Final Explosive Site Plan

OPERATION AND MAINTENANCE OF SAND CREEK BARRIER SYSTEM

RAVENNA ARMY AMMUNITION PLANT
RAVENNA, OH 44266

COMMENT RESPONSE TABLE

Figure 3 - Location of Storage Igloo
 1501 at ODA2 and 7-C-1

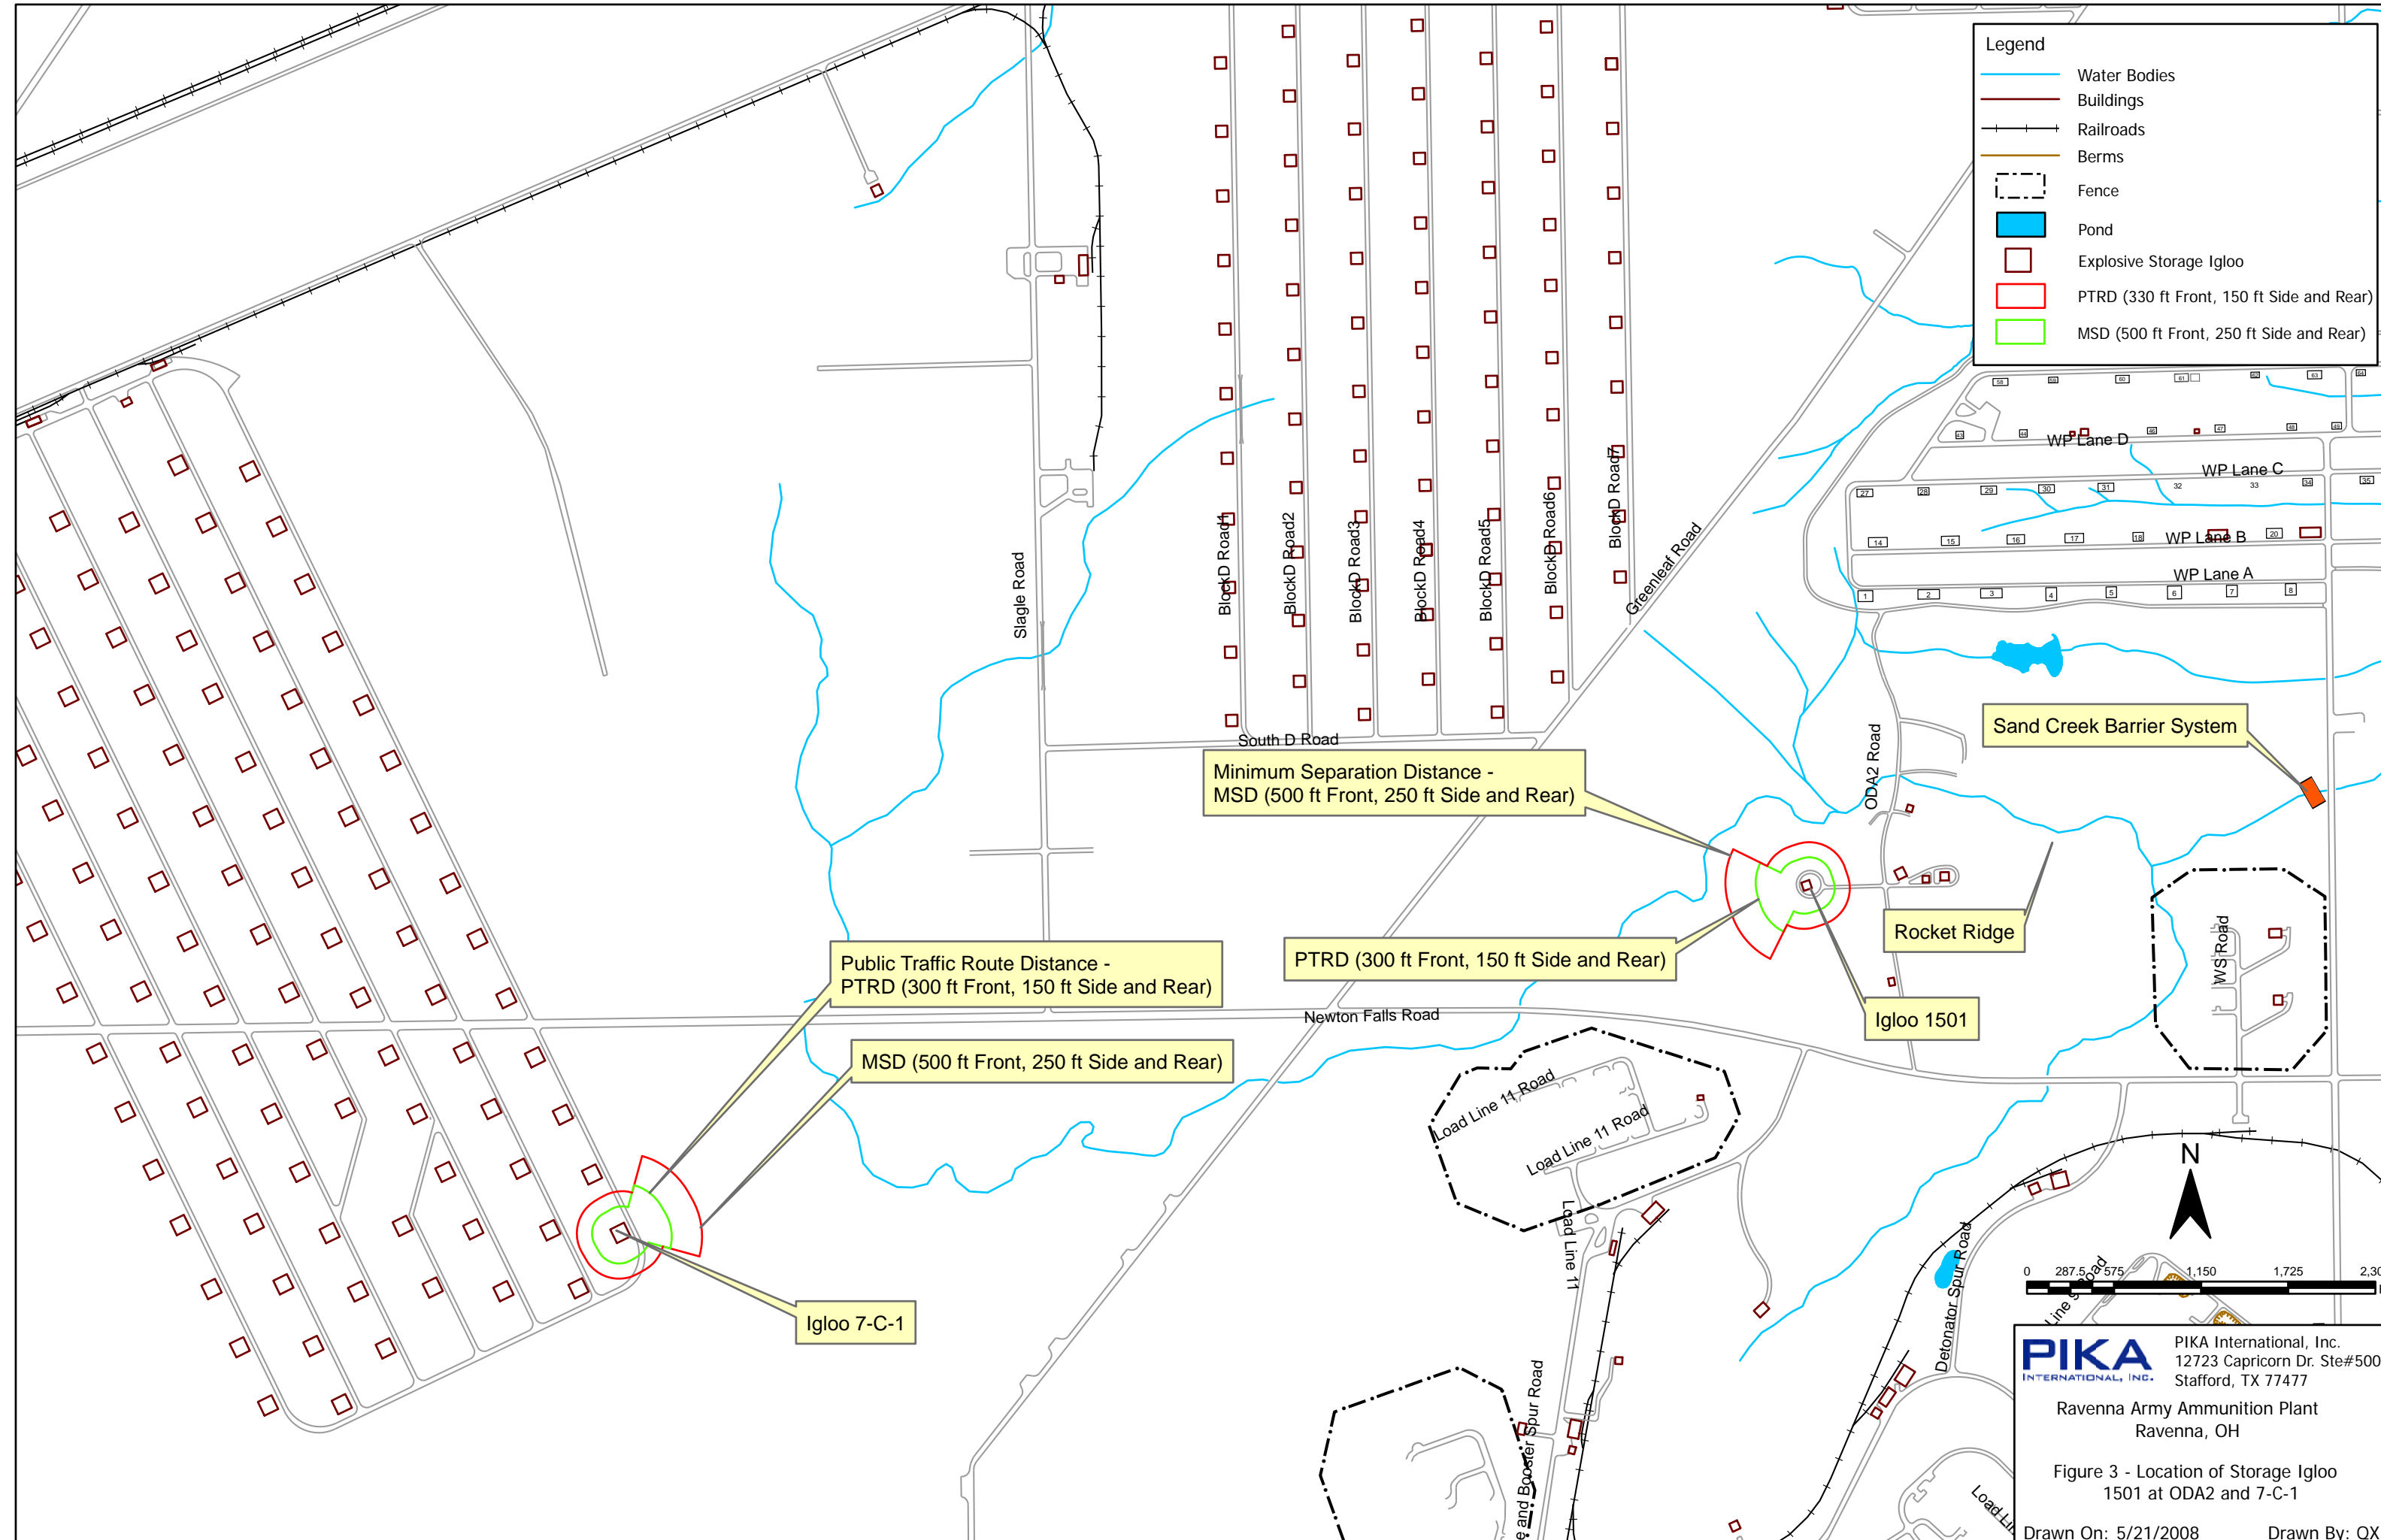
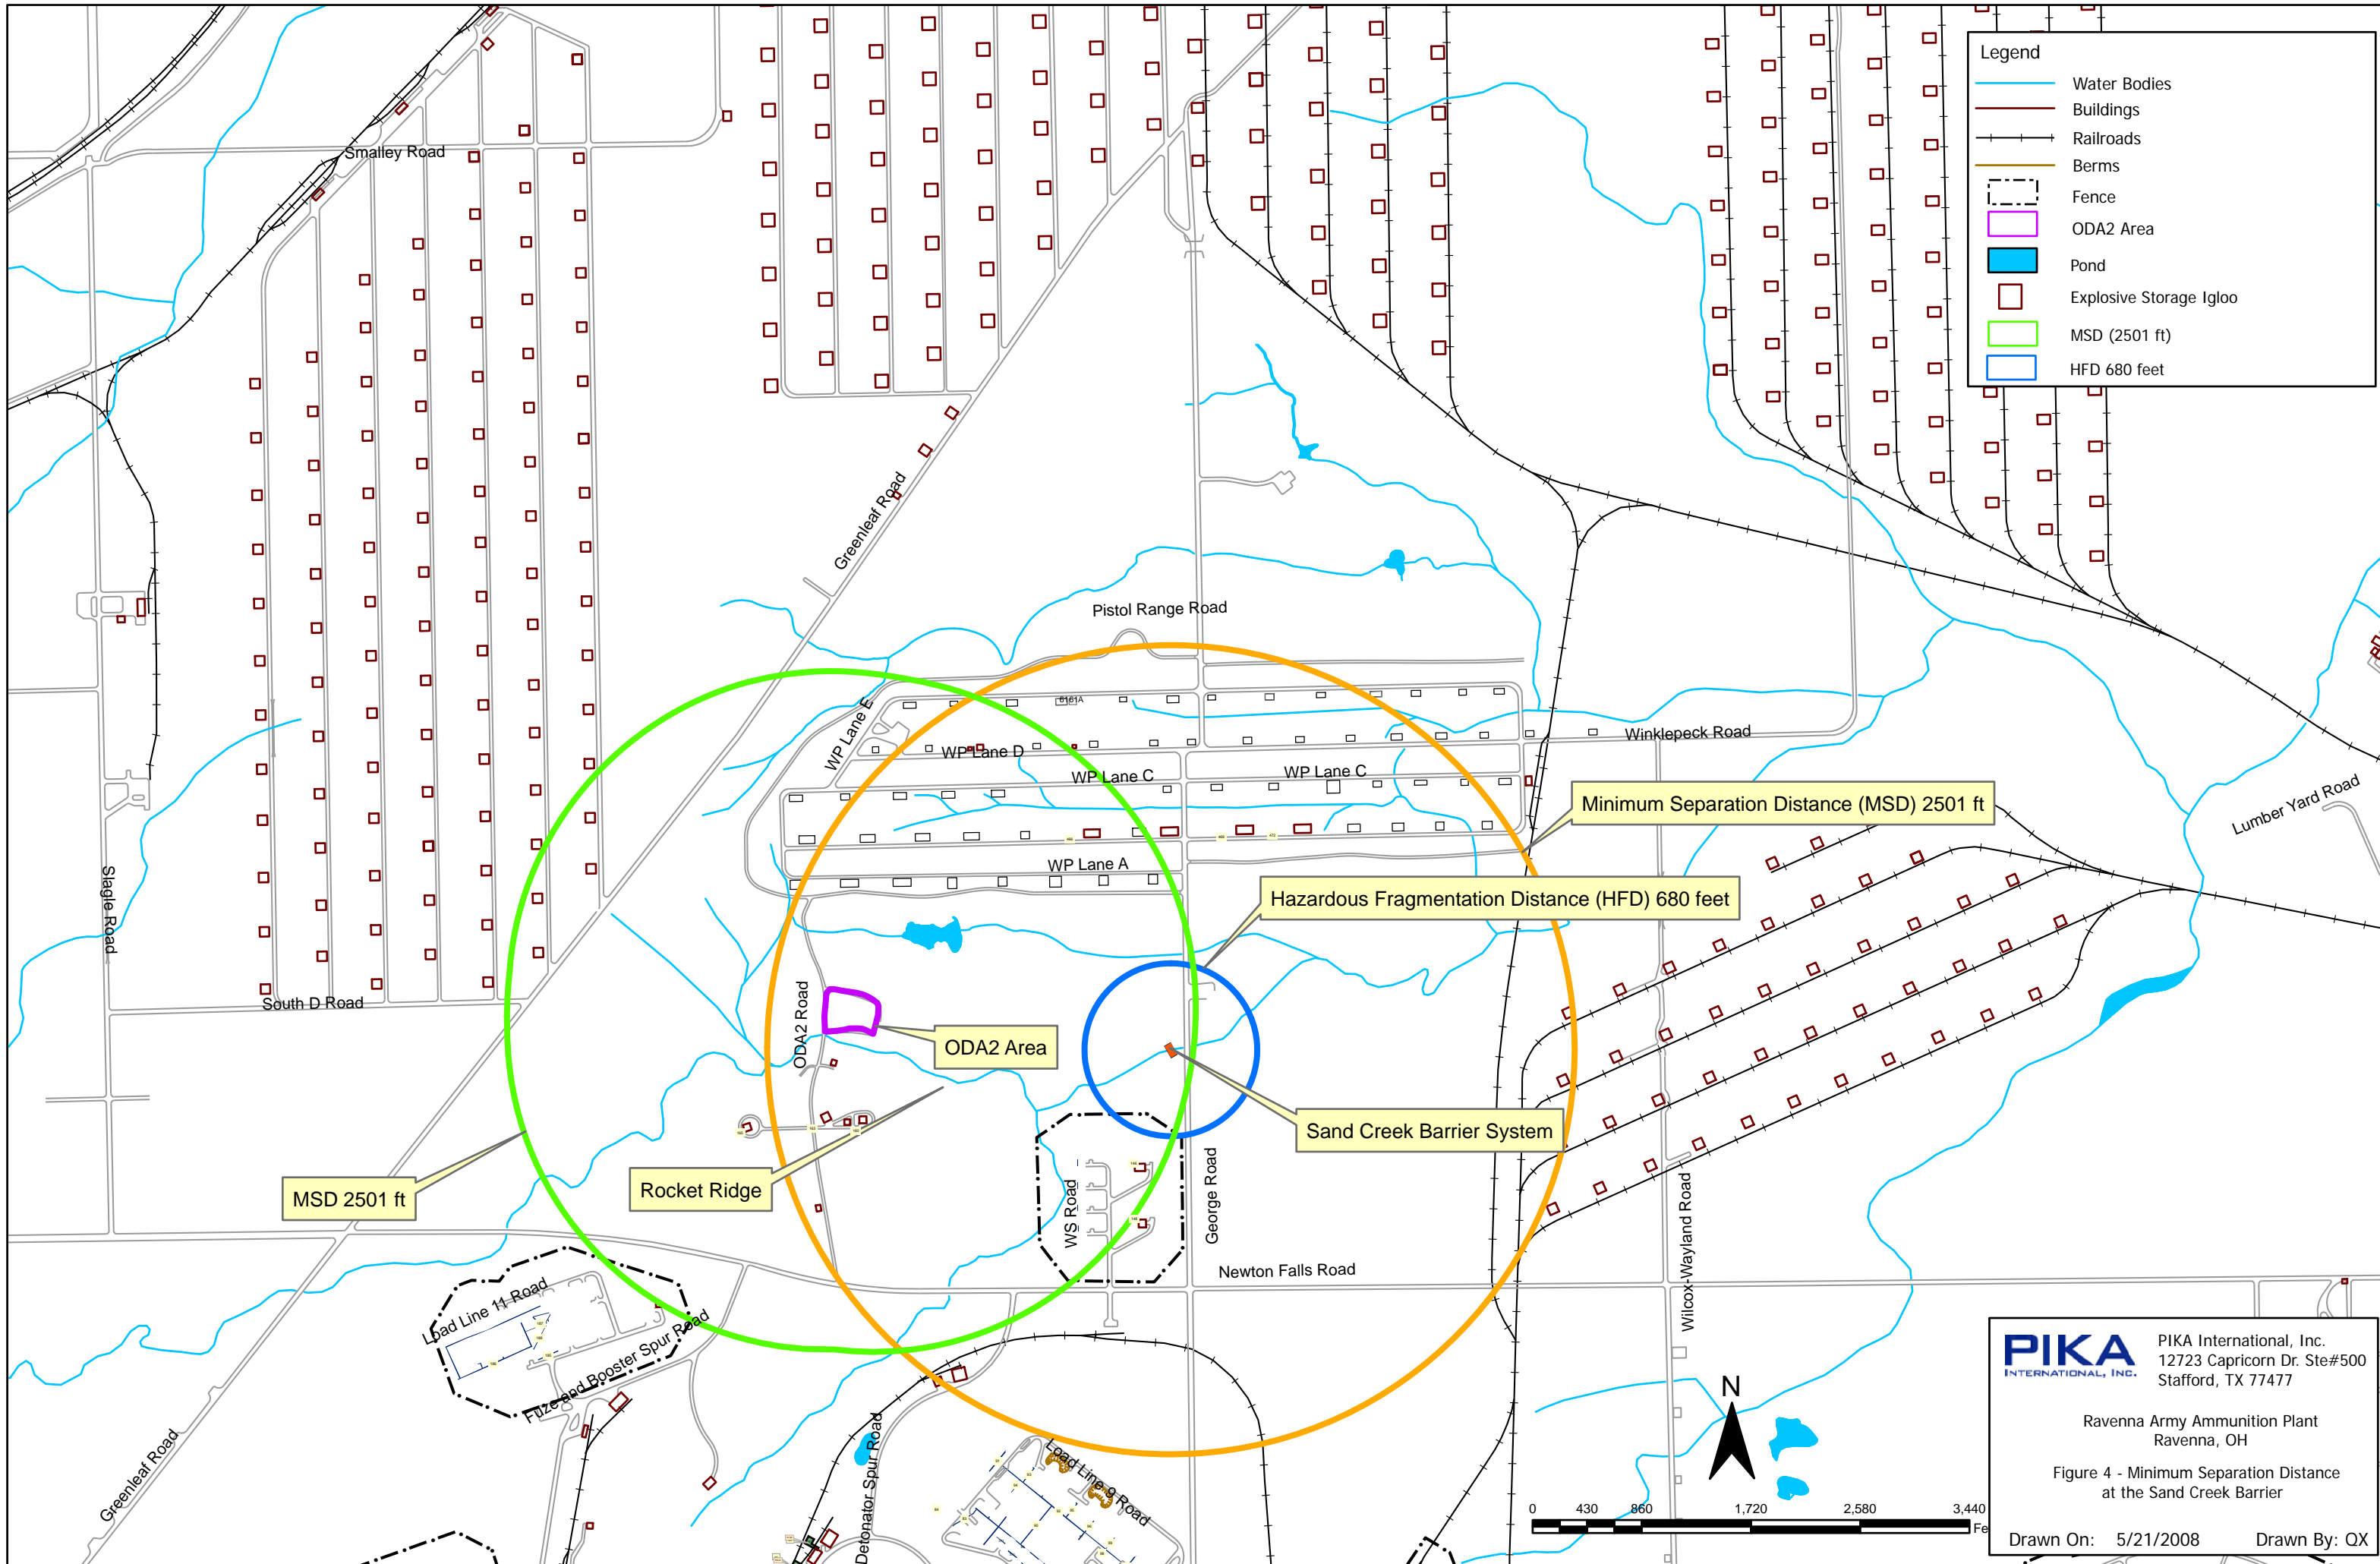
ESP				
4	ESP – pg 2, item 4e	Tense correction needed.	Change tenses in the first 2 sentences in this item to match. (One is currently past tense, one is future tense.)	Tense correction has been made. .., the Army will construct a barrier system.
5	ESP – pg 2, item 7a	Text change. (Because we don’t know all the munitions in Rocket Ridge).	Change text to read: “...., or is expected to be on-site includes: 75 millimeter...”	The text has been revised: “The MEC that has been identified or is anticipated to be present at Rocket Ridge includes...”
6	ESP – App A, fig 1	Legend correction.	What is the “proposed area” denoted in the legend. Remove if necessary.	The Legend denotation was corrected to Sand Creek Barrier System
7	ESP – App A, fig 3	Map changes requested.	a. remove “crop” ☺ circles from the map.	The map has been revised as follows: a. The circles were removed

CMT. #	DOCUMENT/ PAGE #/	REVIEWER COMMENT	REVIEWER RECOMMENDATION	PREPARER RESPONSE
			b. several Slagle Roads... confirm or change. c. add igloos to the legend. d. what is the "proposed area" denoted in the legend? Remove if necessary. e. the amount of added detail to this map is not needed. For example: buildings at LL9 and 11 are gone, most of the Wet Storage igloos are gone, etc.. Update to reflect current conditions. f. define PTRD somewhere. Add an acronym list to the front of the document? g. label Rocket Ridge.	b. The Slagle Road denotation has been changed. c. Igloos were added to the legend. d. The "Proposed Area" denotation has been removed. e. The map has been updated to reflect current conditions. f. PTRD has been defined on map. Acronym list was added. g. Rocket Ridge has been labeled.
8	ESP – App A, fig 4	Map changes requested.	a. remove "crop" ☺ circles from the map. b. add igloos to the legend. c. the amount of added detail to this map is not needed. For example: buildings at LL9 and 11 are gone, most of the Wet Storage igloos are gone, etc.. Update to reflect current conditions. d. add igloos to the legend.	The map has been revised as follows: a. The circles were removed. b. Igloos were added to the legend. c. The map has been updated to reflect current conditions. d. Igloos were added to the legend.
